Re: Amendment to Steep Slope approval
Addition and alteration to
Existing 1 family dwelling
6 Fulton Street
Hastings on Hudson, New York
DAB Job # 160901

Attached please find three (3) copies of As-built Site Plans for review to amend the previously approved Steep Slope application.

Re: Amendment to the Steep slope analysis for
Addition and alteration to
Existing 1 family dwelling
6 Fulton Street
Hastings on Hudson, New York
DAB Job # 160901

Re: Special hardship exception (Section 249-8)
to Steep Slope amended approval for the
Addition and alteration to
Existing 1 family dwelling
6 Fulton Street
Hastings on Hudson, New York
DAB Job # 160901

SP1

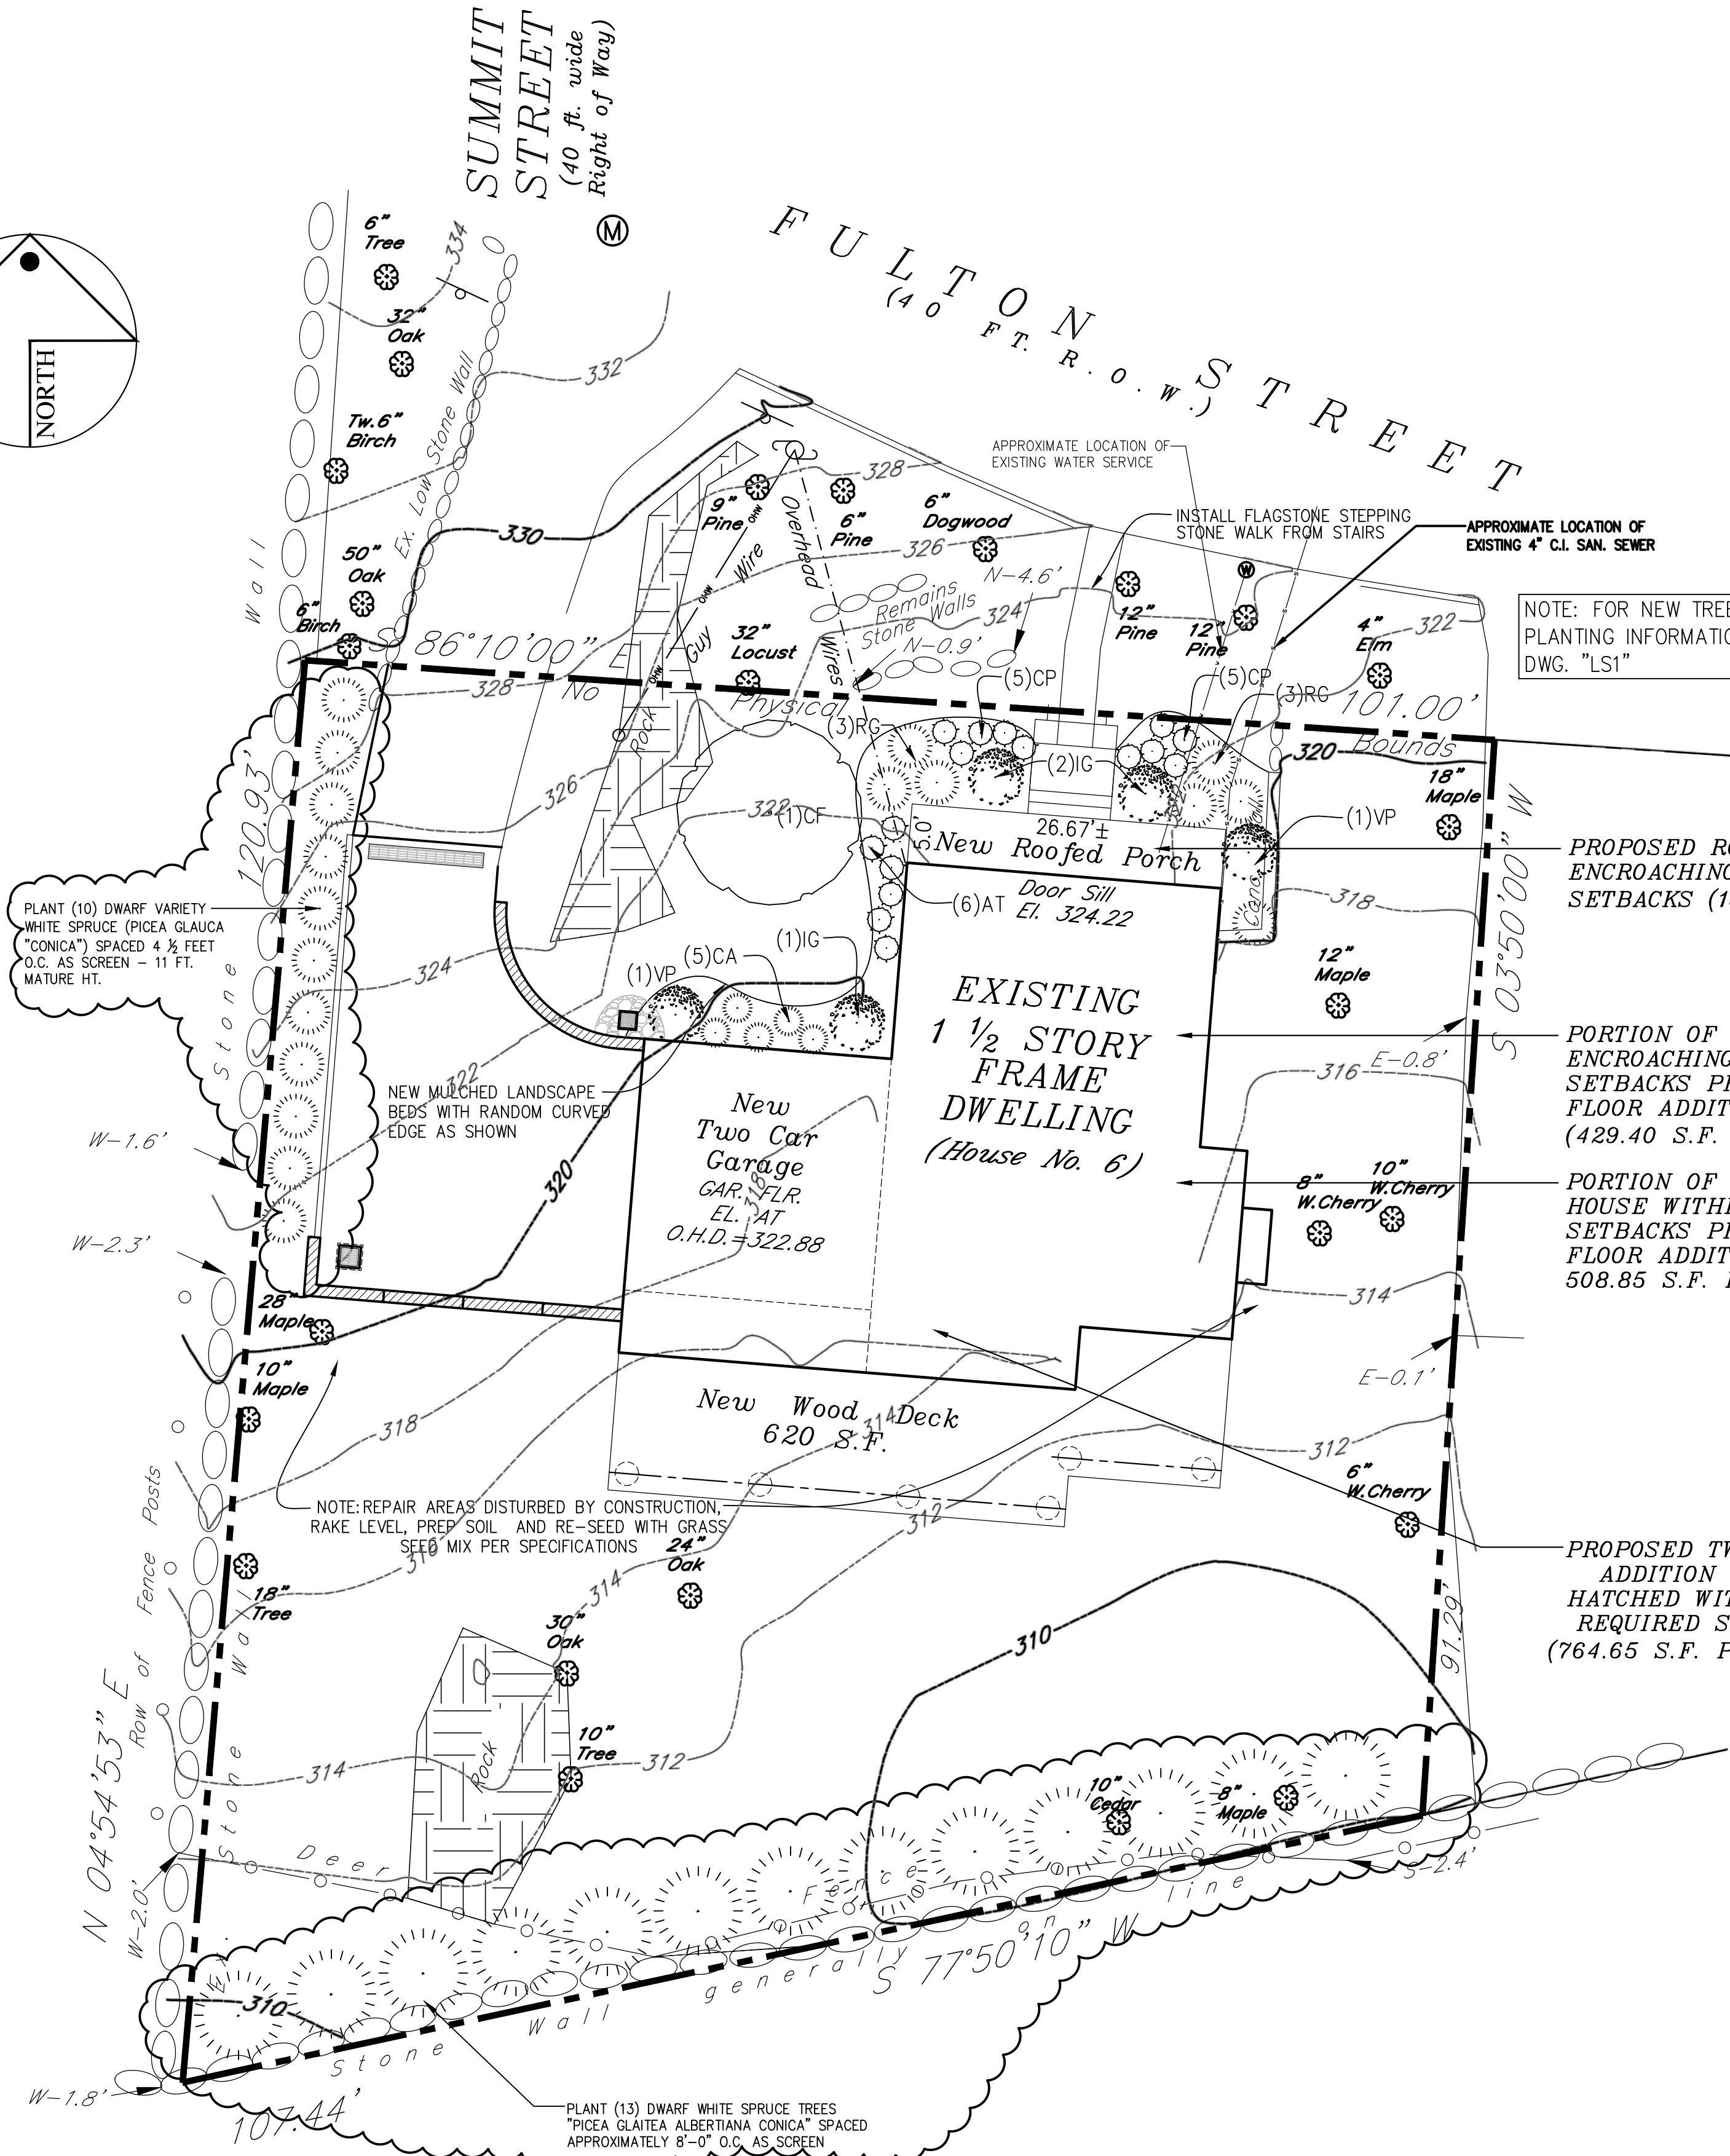
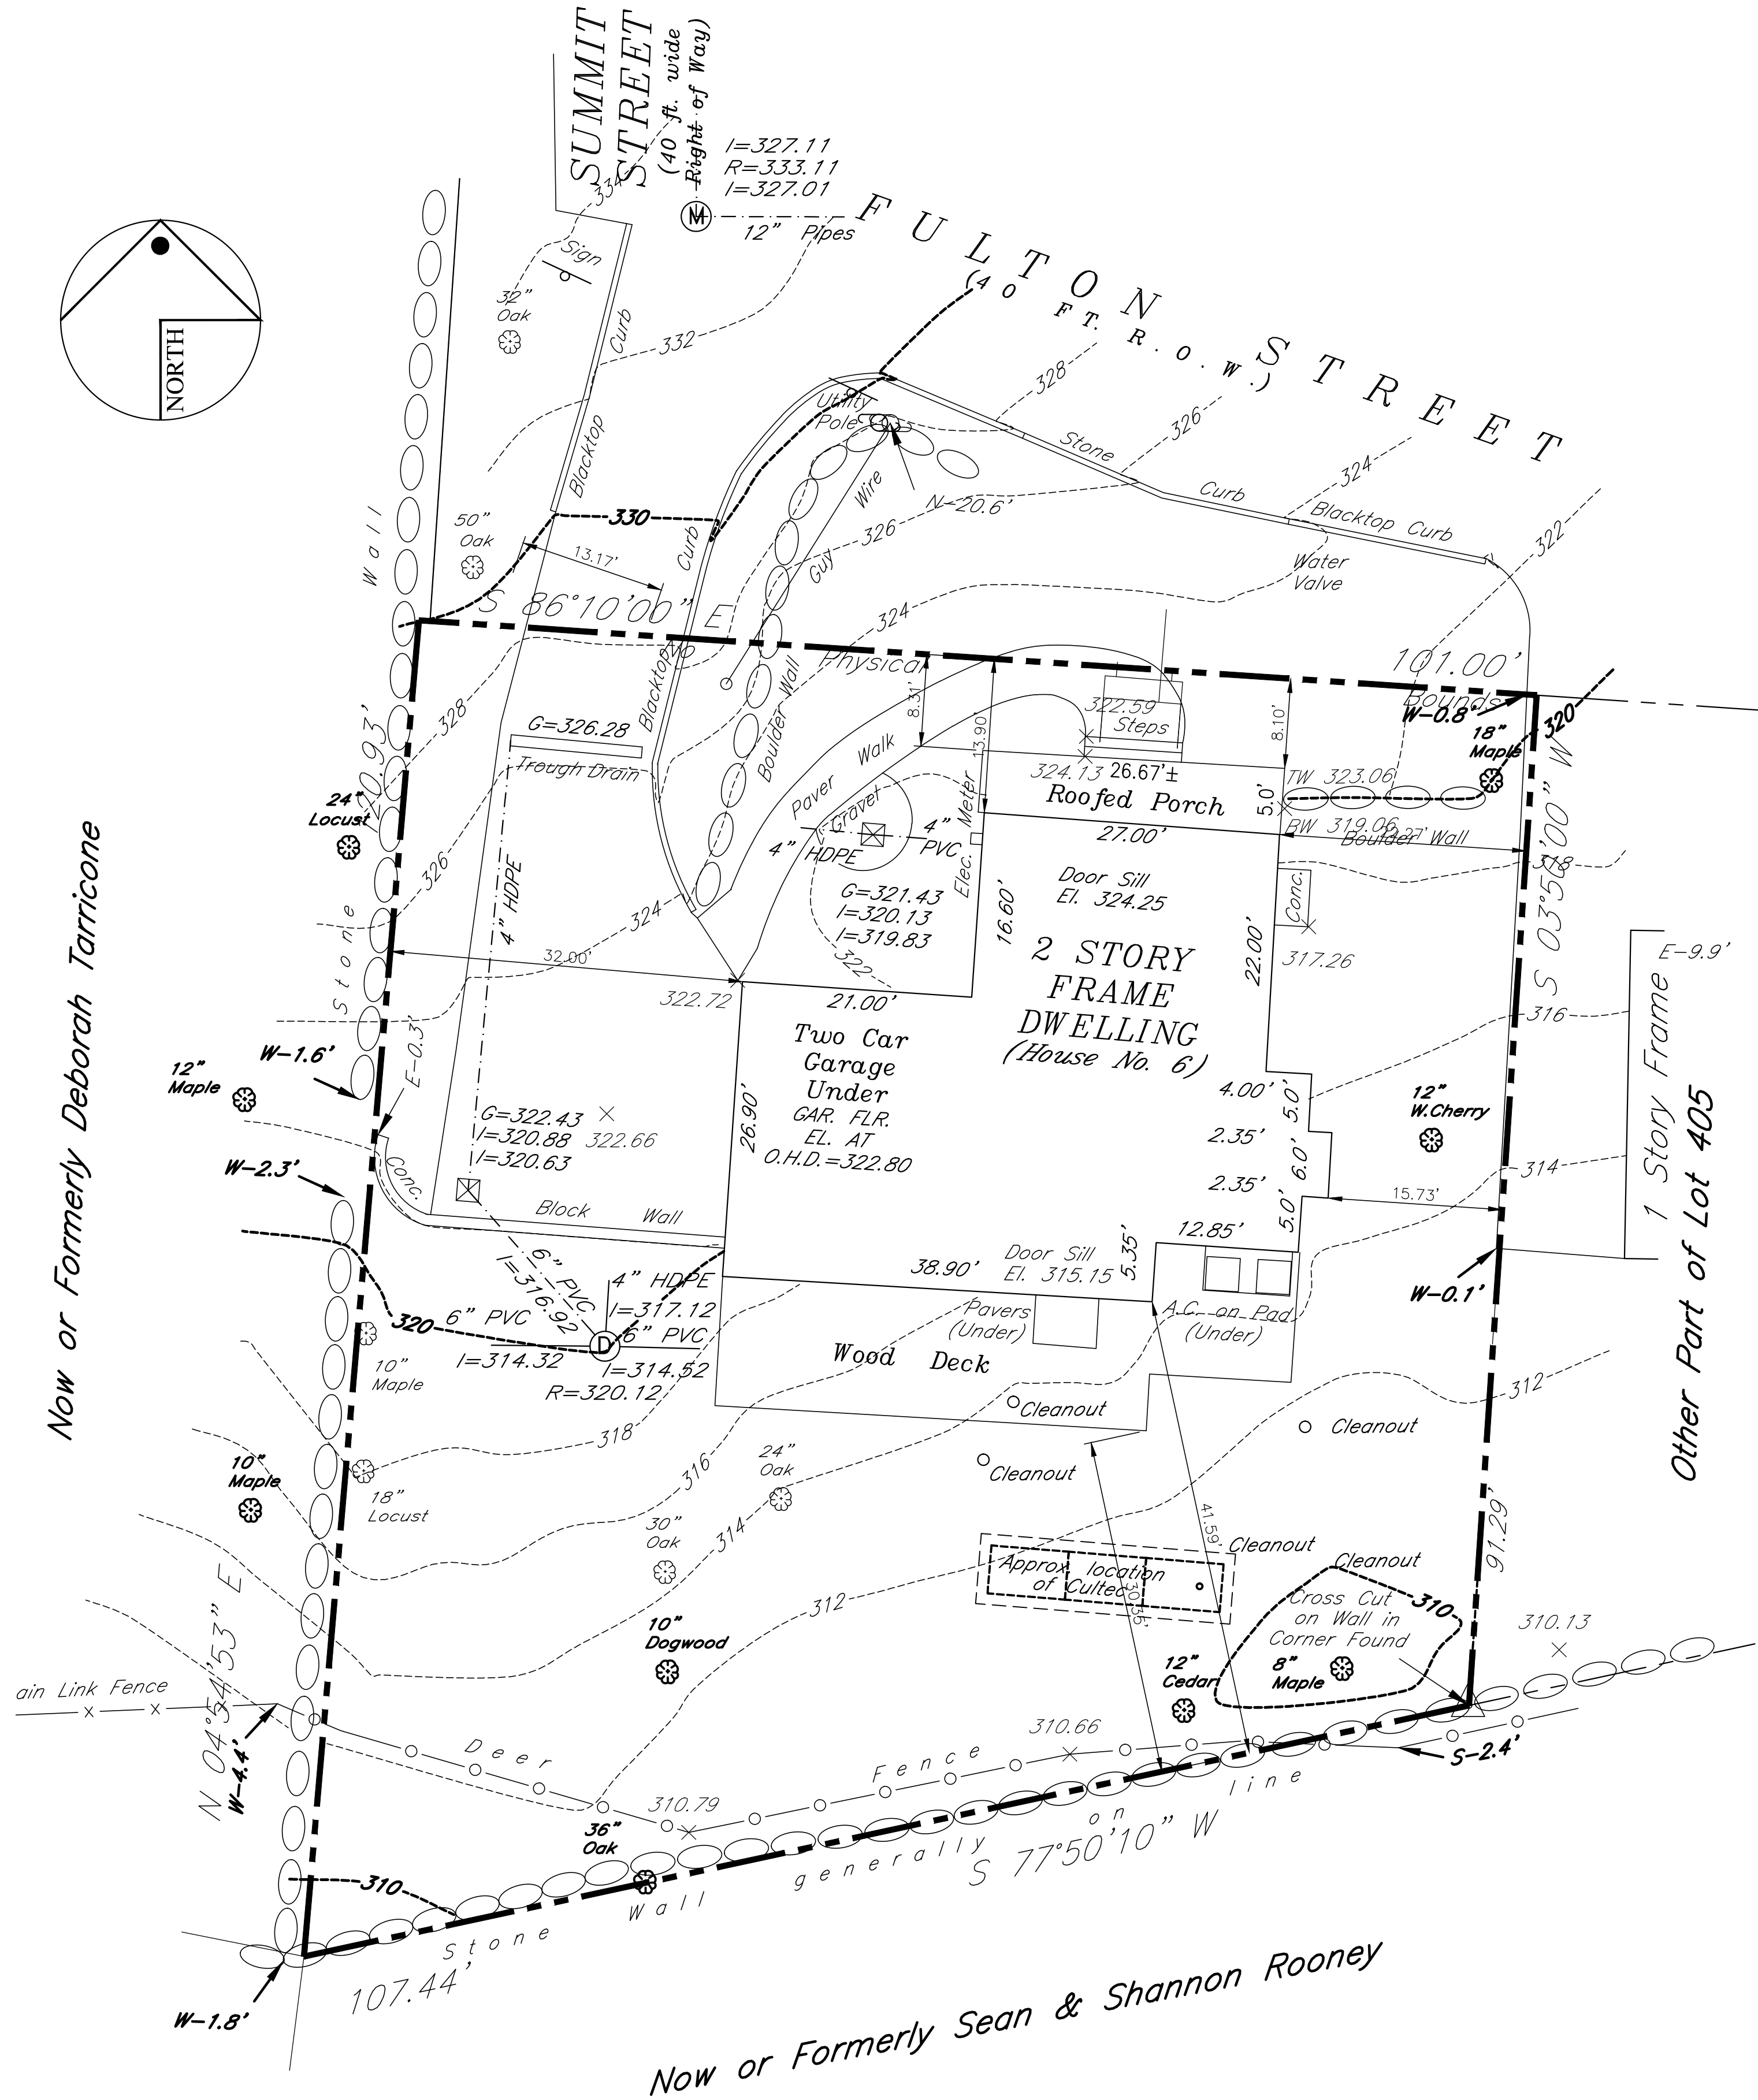
The following is a brief summary of modifications to the previously approved Steep Slope application and Site Plan drawings.

- The front sidewalk was removed, and a new paver sidewalk leading to the new driveway was installed. The existing sidewalk encroachments in the Village right-of-way were removed, and said area was stabilized and seeded.
- The number of proposed trees along the southerly and easterly property lines was reduced due to the fact that areas had encountered subsurface rock, prohibiting the planting of all of the approved number of trees. The number of trees reduced at the southerly property line was 5, and at the easterly property line was 2.
- The Contractor regraded areas at the rear of the dwelling, which added sq. footage to the total areas of the 15%-25% (+1,140 sq. ft.), and in the 25% and greater areas (+199 sq. ft.), as indicated by the revised Steep Slope Analysis as prepared by Ward Carpenter Land Surveyors dated July 19, 2018.
